Public Notice – Proposed Traffic or Parking Amendment

Reference No	TR2024/00590
Road/s	Buxton Lane, Adamstown
Traffic Engineer	William Arundell, Traffic Engineer
Contact No	4974 2000
Approval Authority	City of Newcastle
Notice/Submission Period	3 June 2024 to 17 June 2024

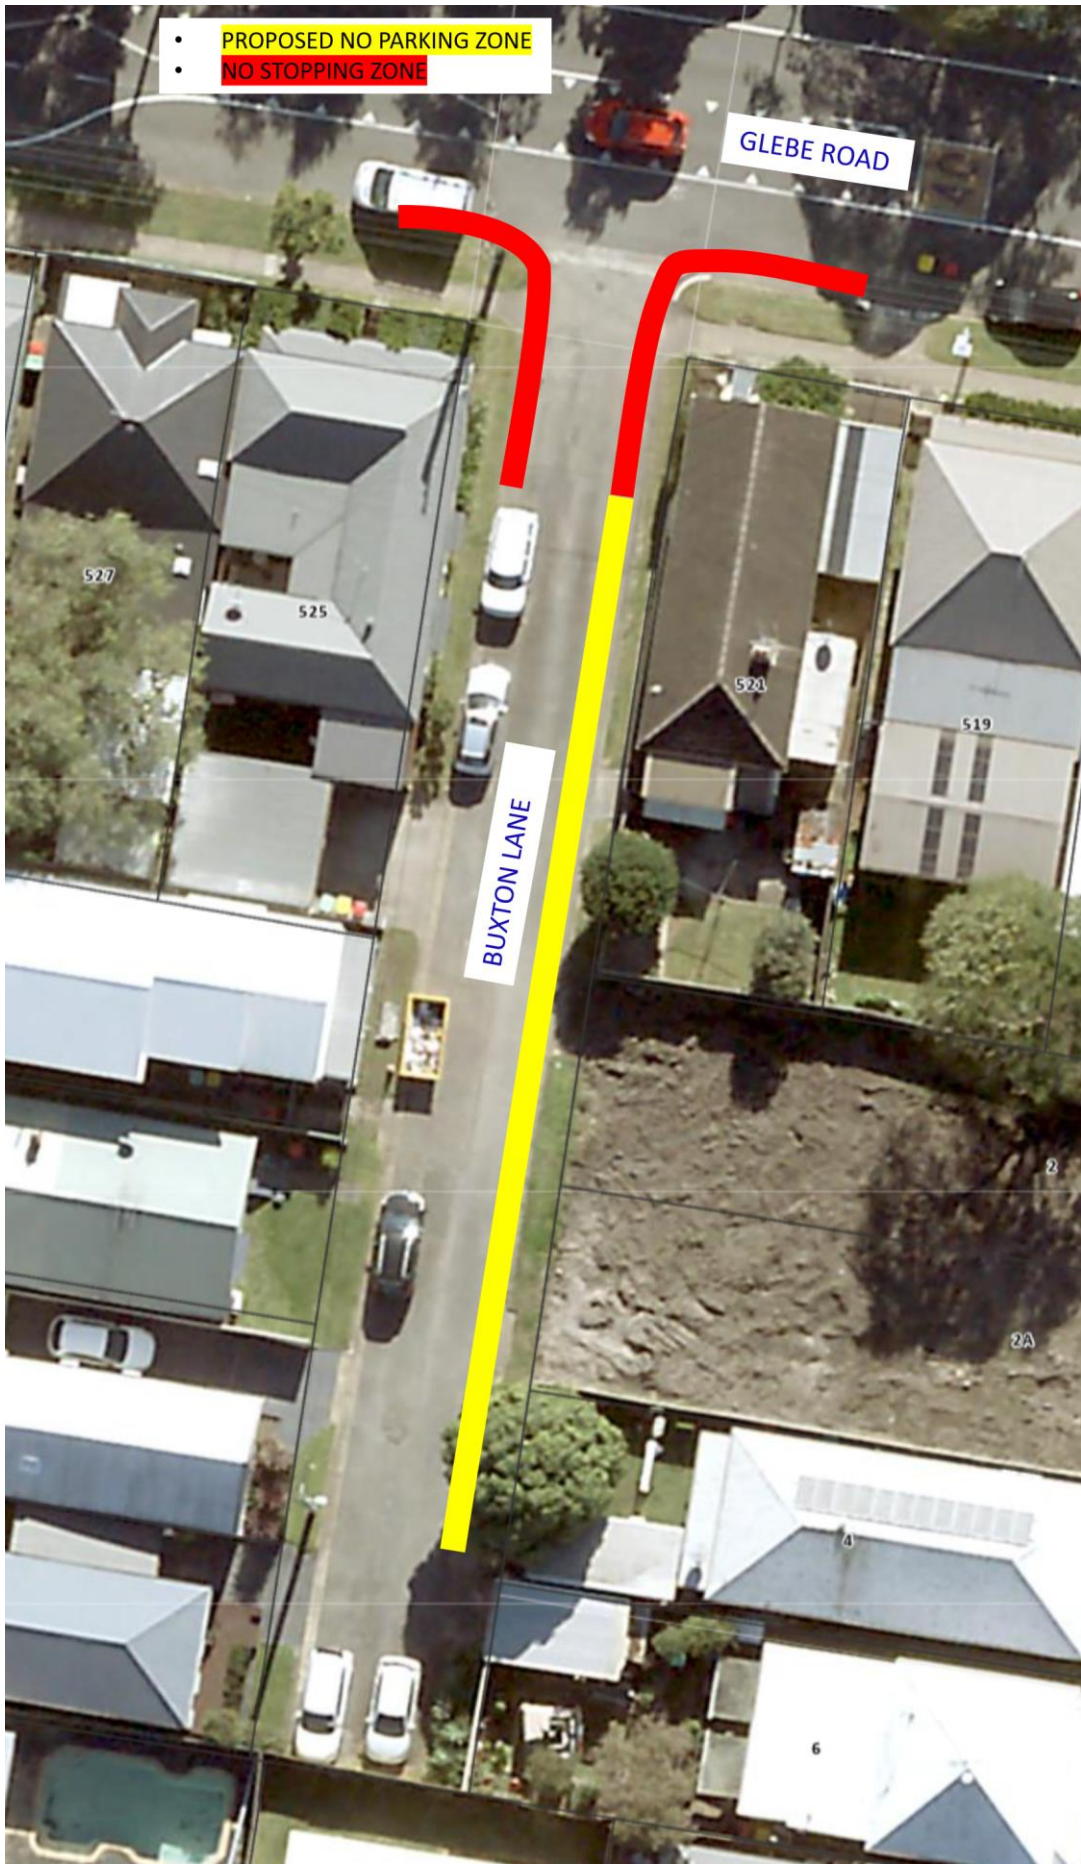
It is proposed to install No Parking signs on the east side of Buxton Lane Adamstown, a regulatory No Stopping signs at the intersection with Glebe Road.

The proposed changes are in response to requests from local residents to improve vehicle access in this street, as vehicles are reported to be regularly obstructing the lane by not providing the required 3 metres passing width when parking (as is required by the NSW Road Rules).

Inspections of the area have indicated that the lane is approximately 6 metres in width indicating that parking can only legally occur on one side of the street at any point.
